UNITED STATES
DEPARTMENT OF THE INTERIOR
BUREAU OF LAND MANAGEMENT

FORM APPROVED
OMB NO. 1004-0137
Expires: January 31, 2018**SUNDRY NOTICES AND REPORTS ON WELLS**
*Do not use this form for proposals to drill or to re-enter an abandoned well. Use form 3160-3 (APD) for such proposals.*5. Lease Serial No.
NMNM07260

7. If Unit or CA/Agreement, Name and/or No.
89100850108. Well Name and No.
INDIAN HILLS UNIT 249. API Well No.
30-015-31266-00-S110. Field and Pool or Exploratory Area
INDIAN BASIN-UPPER PENN ASSOC11. County or Parish, State
EDDY COUNTY, NM**SUBMIT IN TRIPLICATE - Other instructions on page 2**

OXY USA WTP LP - Current
Indian Hills Unit #24
API No. 30-015-31266

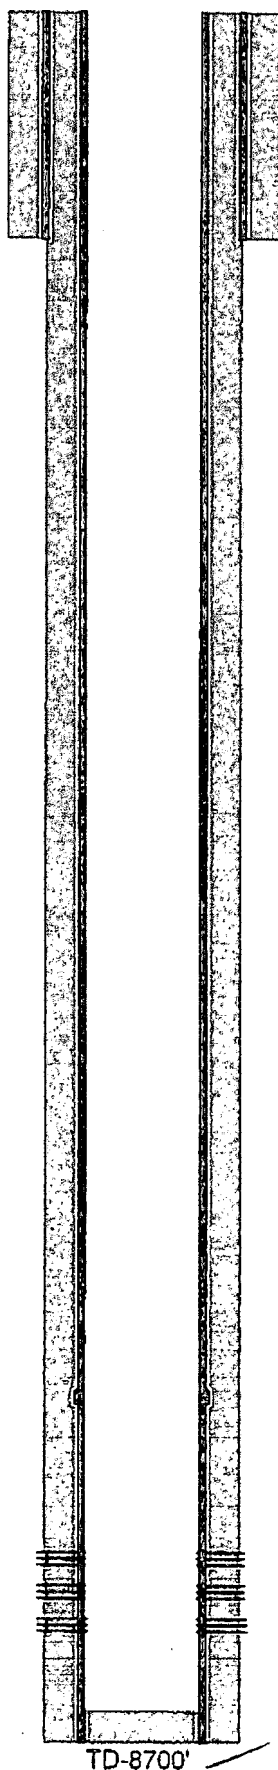
SA 806

GI 2416

Yes 2536

BS 5418

Sand 7094

WC 7234

up 7946

OXY USA WTP LP - Proposed
Indian Hills Unit #24
API No. 30-015-31266

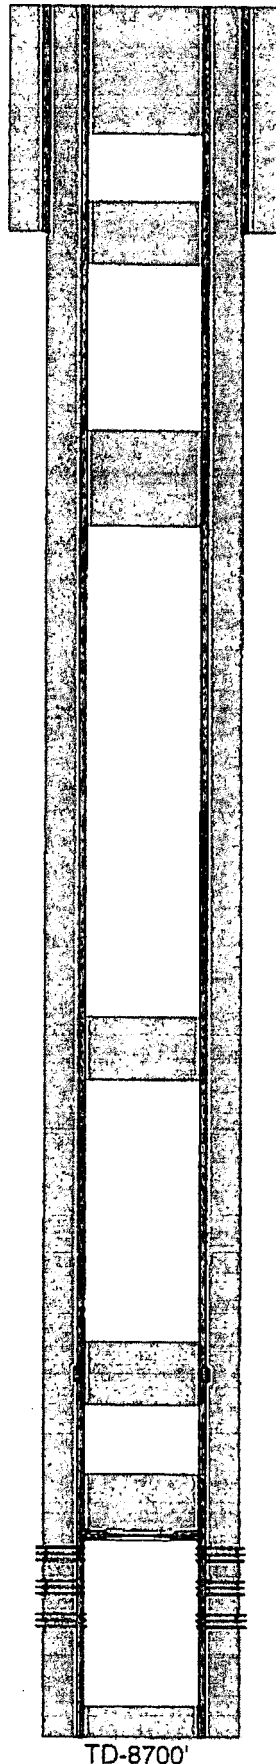
7284- 7015
35sx @ 7115-6940' WOC-Tag
